PLANS AND DOCUMENTS referred to in the PDA DEVELOPMENT APPROVAL

Approval no: DEV2026/NSH/5161

AMENDED IN RED

19 HERCULES ST HAMILTON, BRISBANE QLD 4007

SHEET NO	DA 104	REVISION	C
----------	--------	----------	---

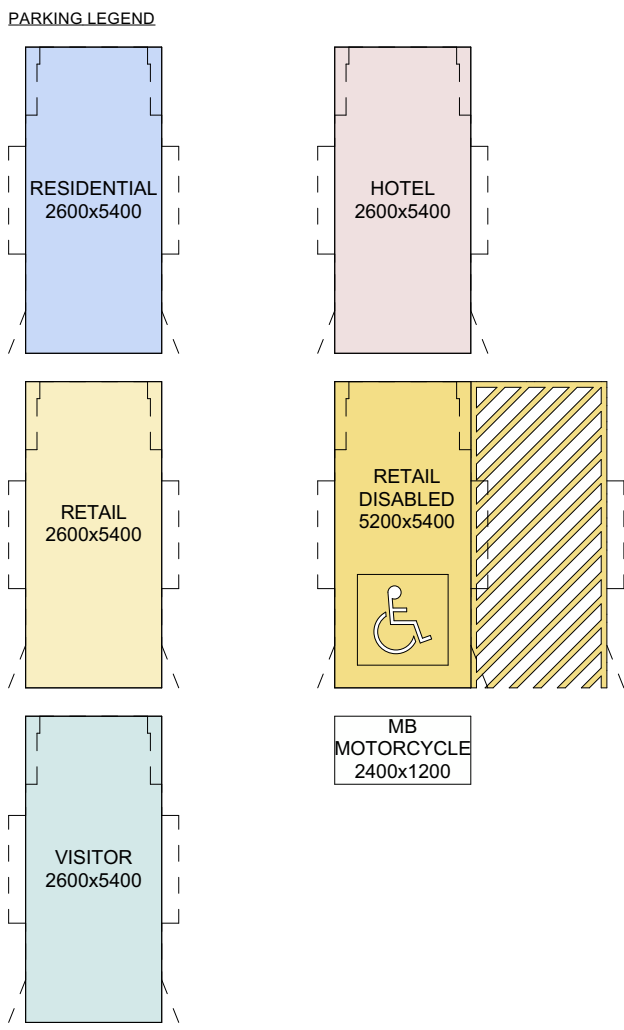
Motorcycle Parking Spaces not supported in these spaces

SHEET NO	DA 105
REVISION	C

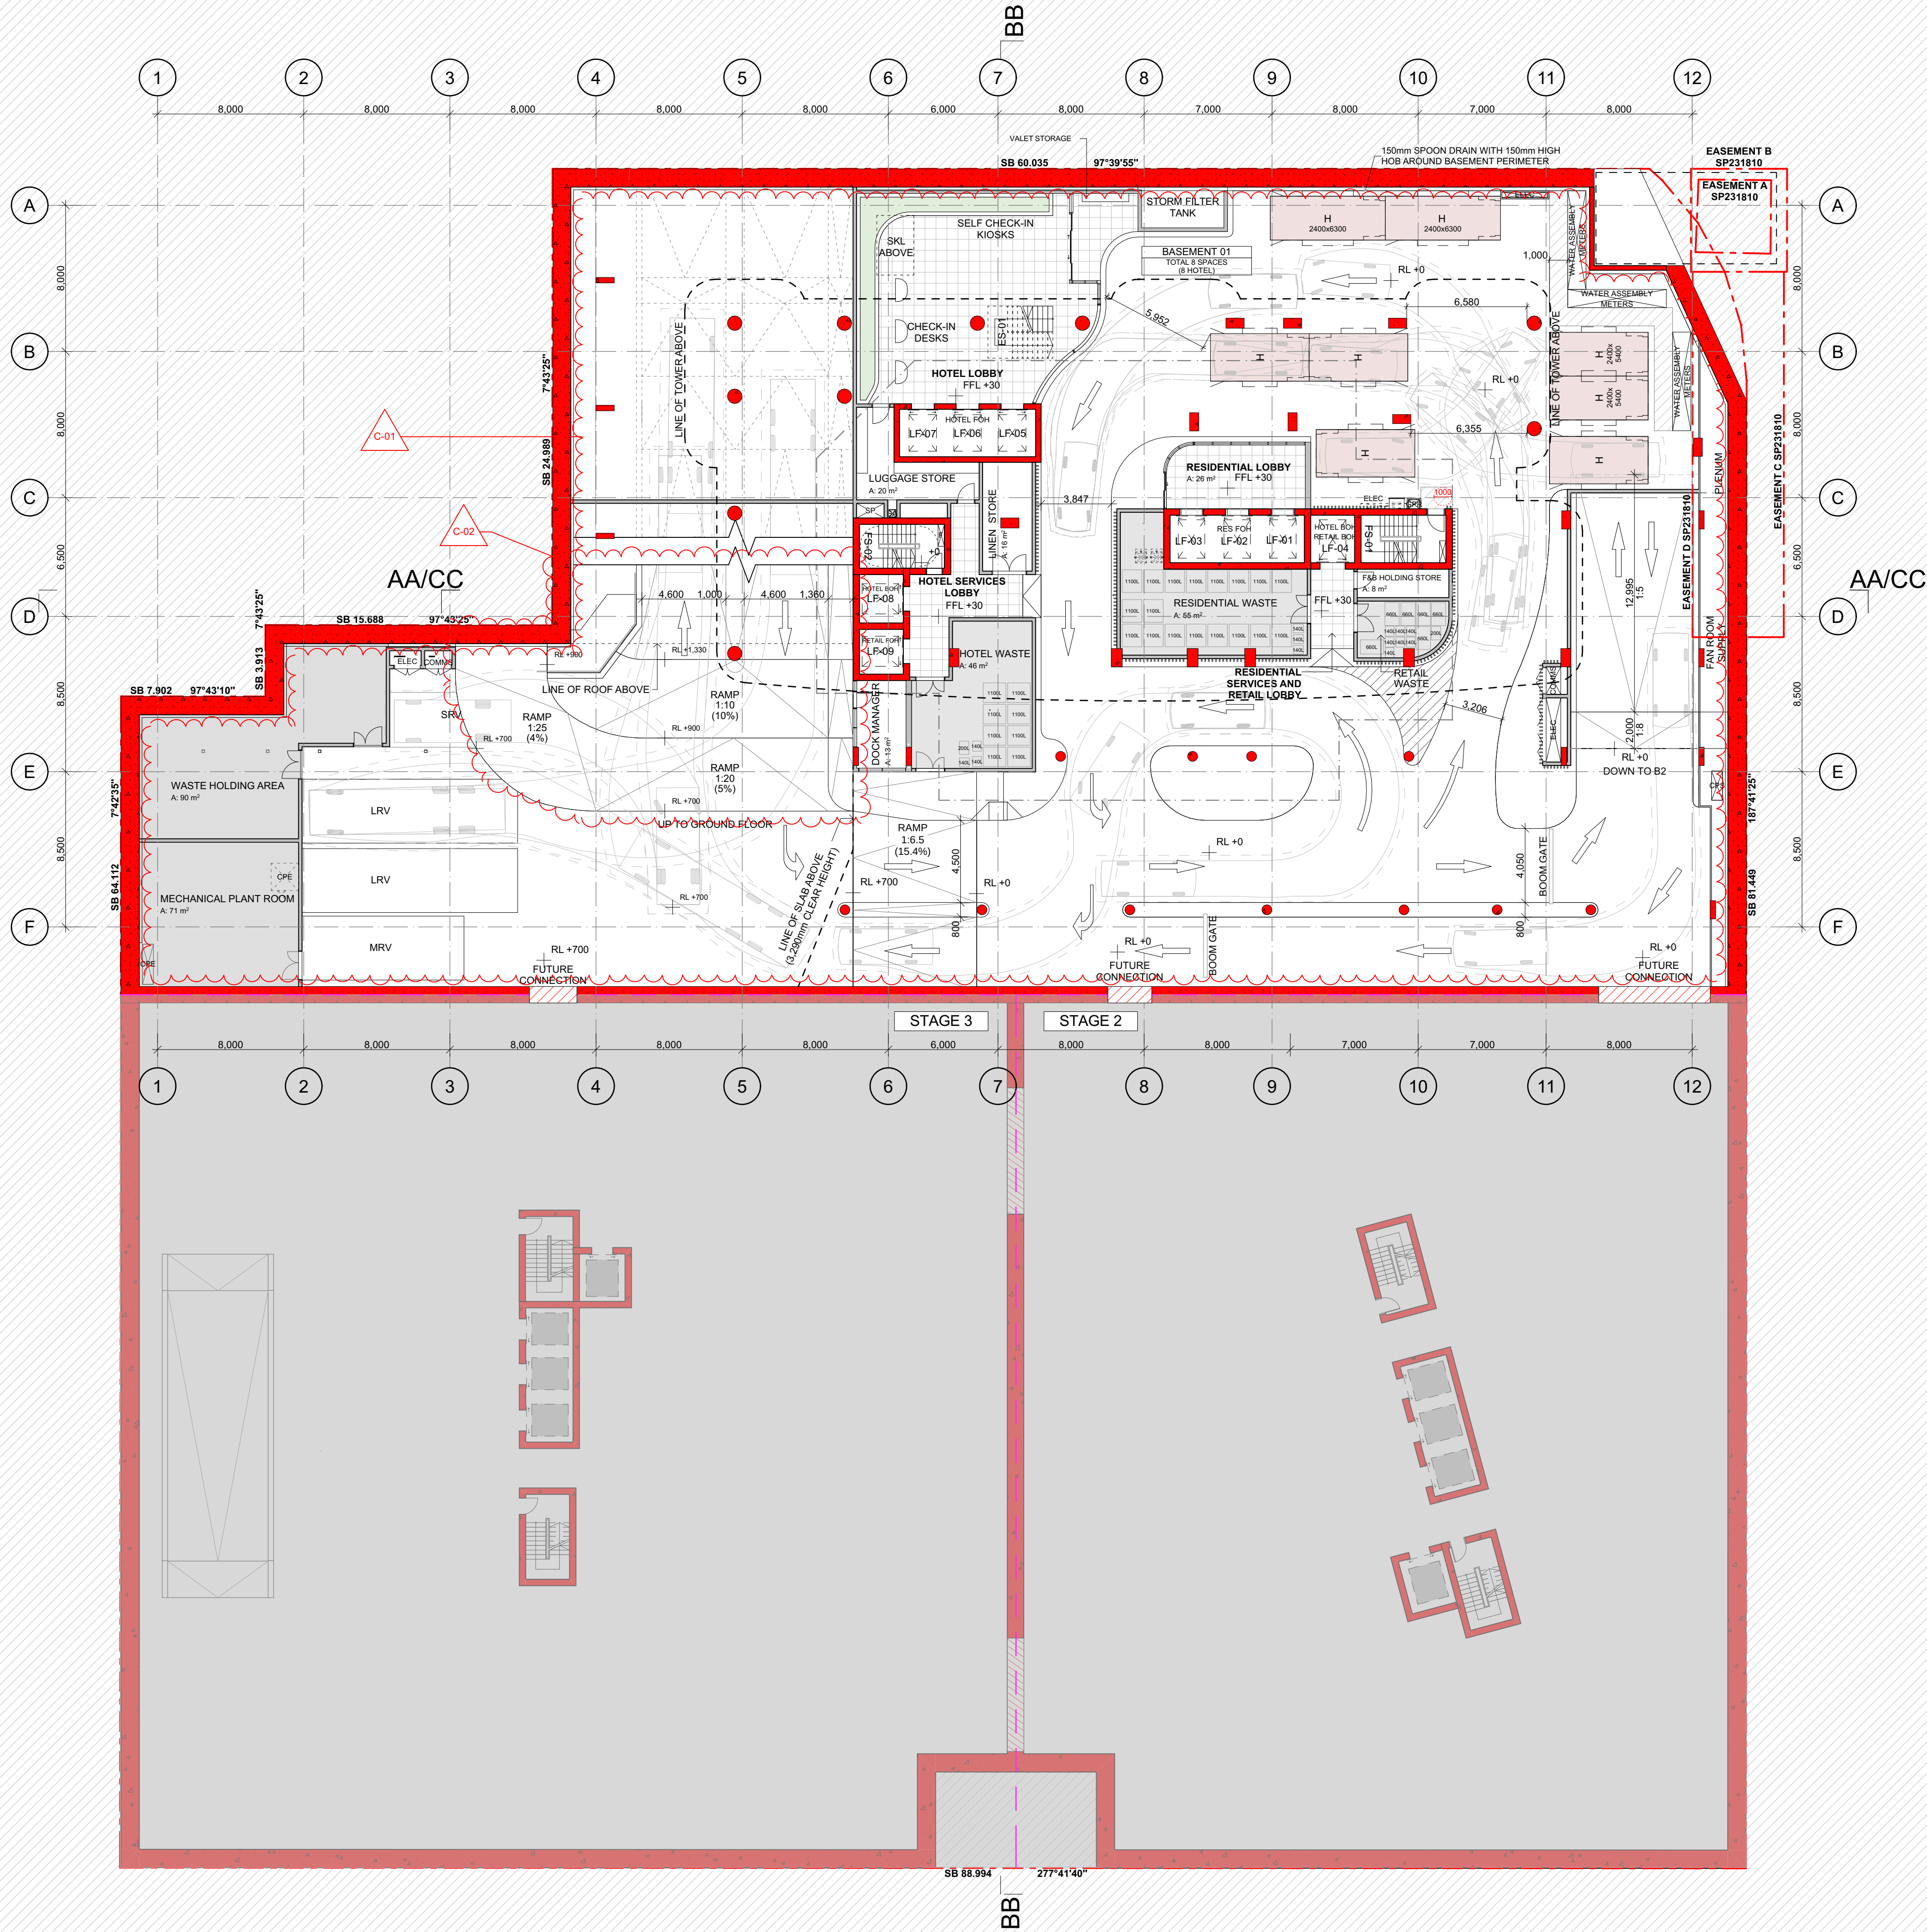
Pedestrian sight splays to be provided as per AS2890.1 - Figure 3.3

DA 106

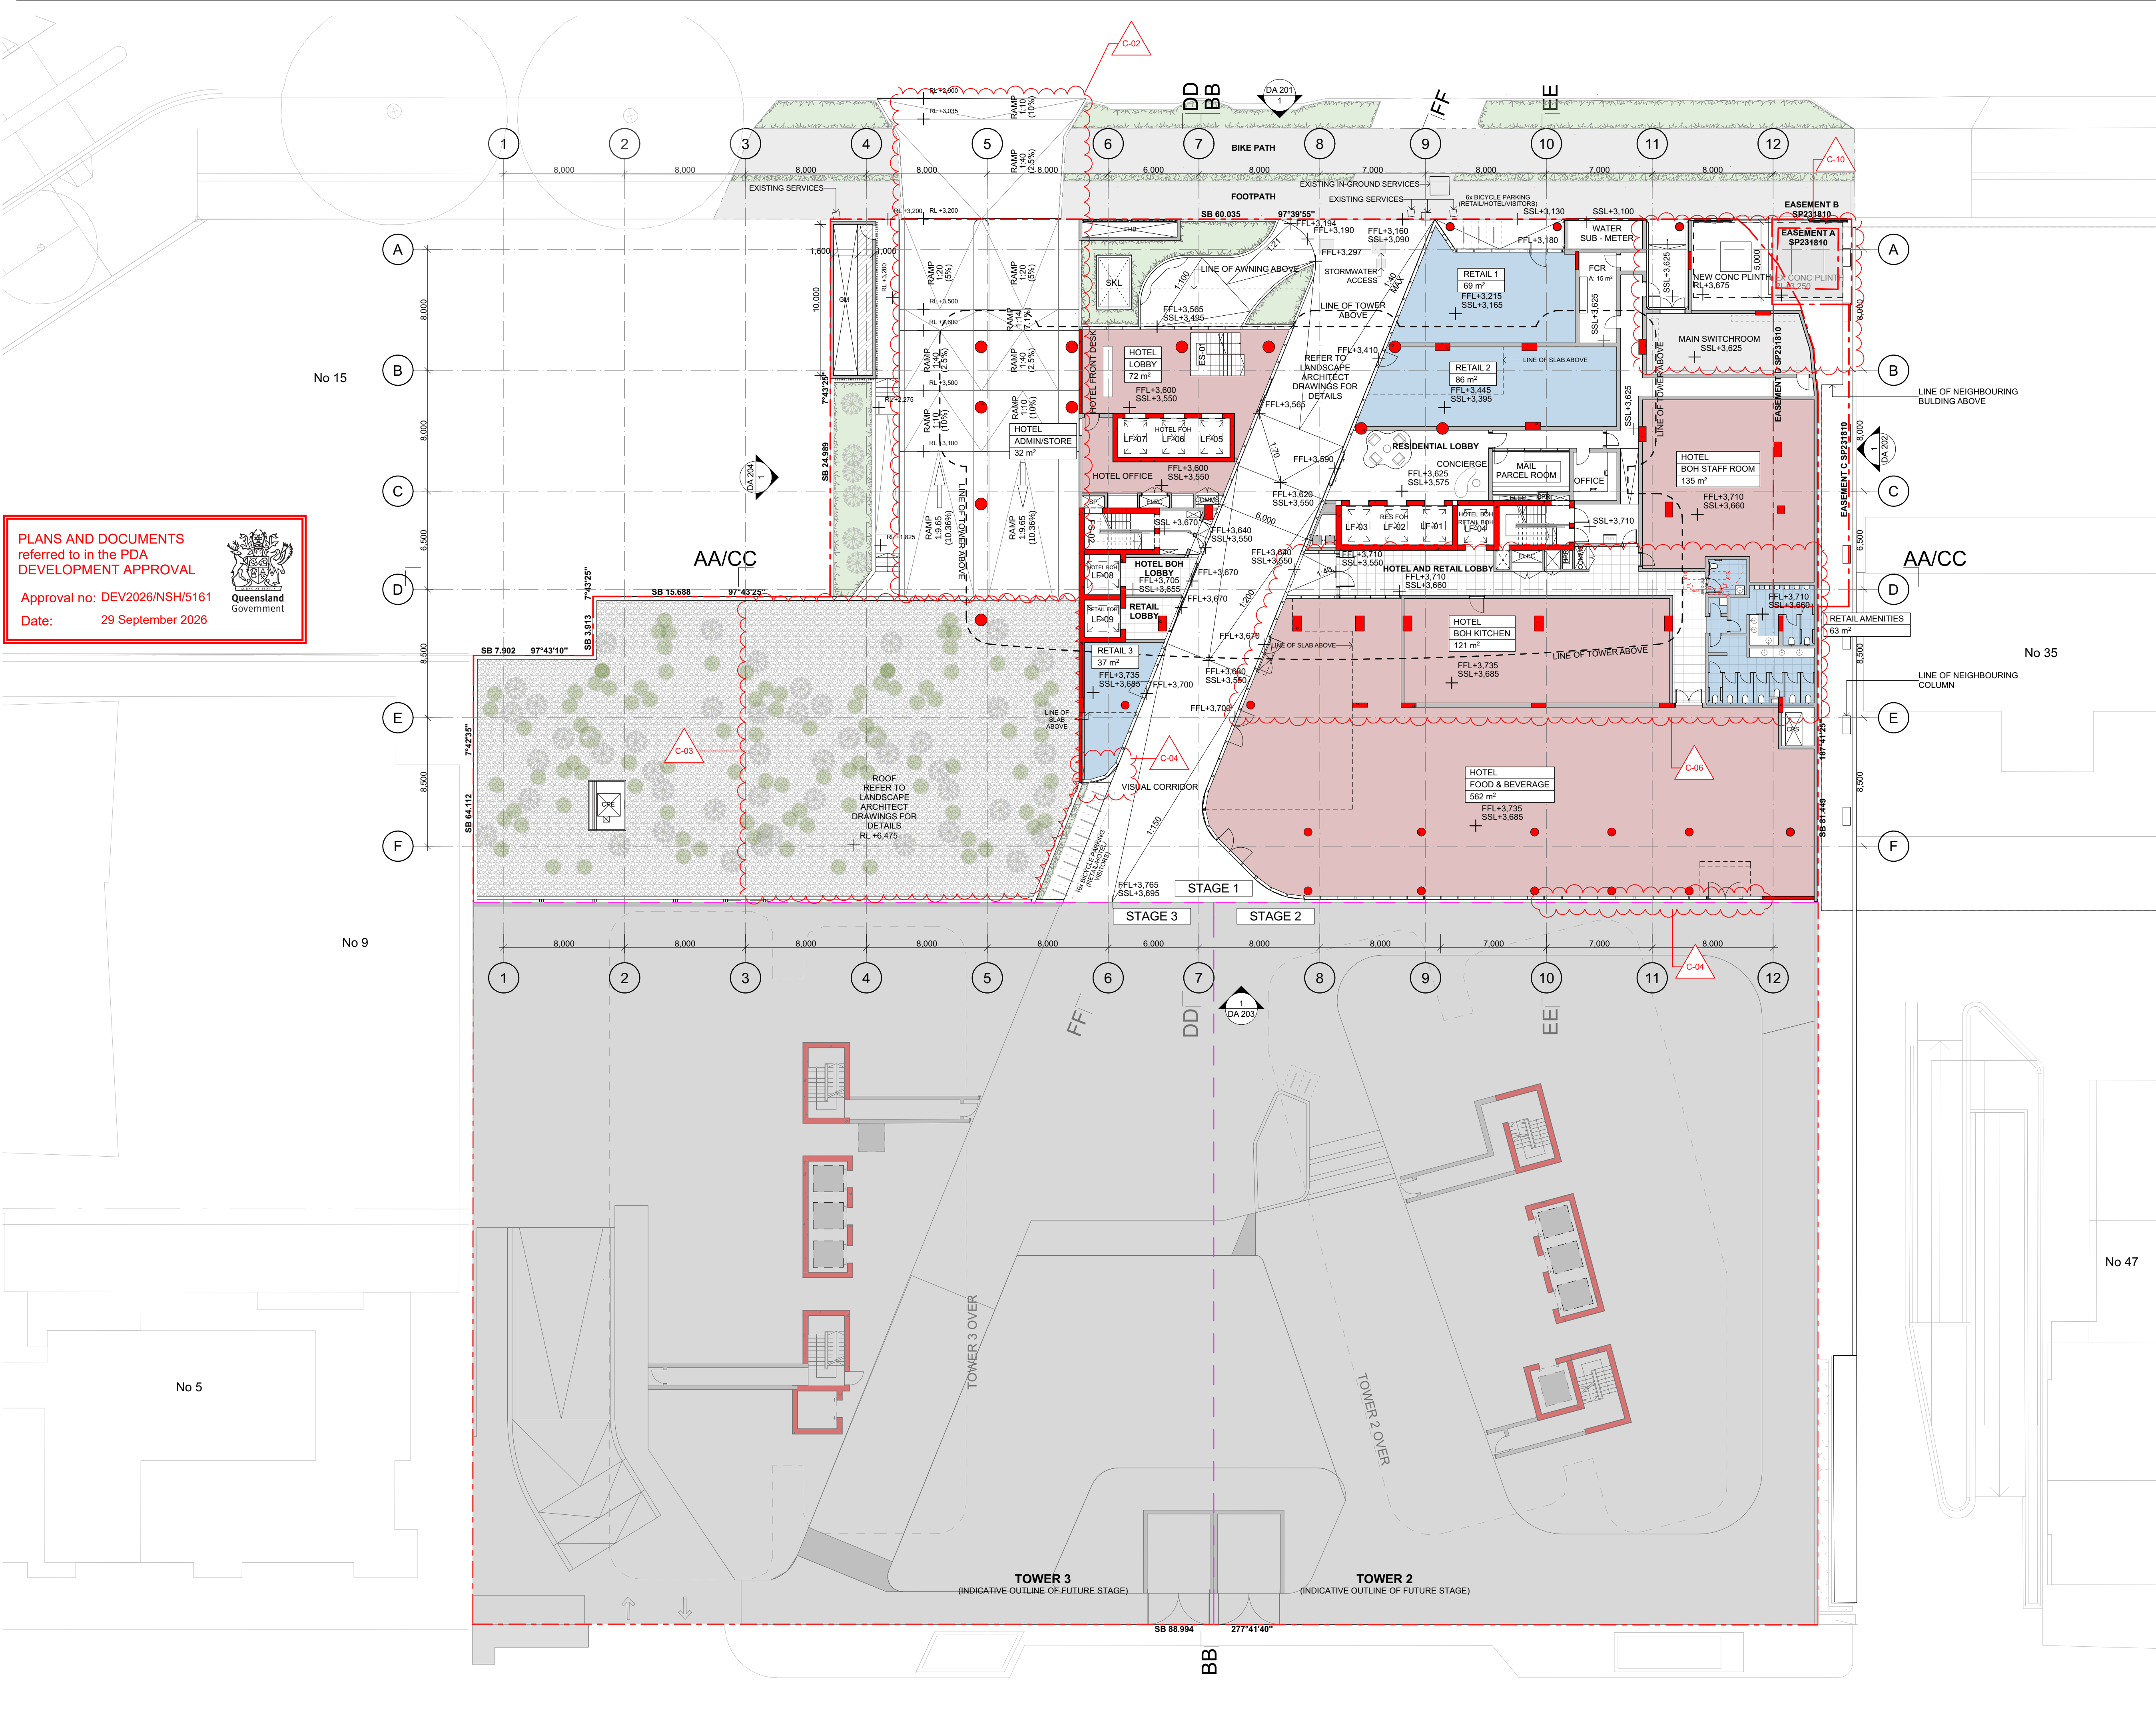
Pedestrian sight splays to be provided as per AS2890.1 - Figure 3.3
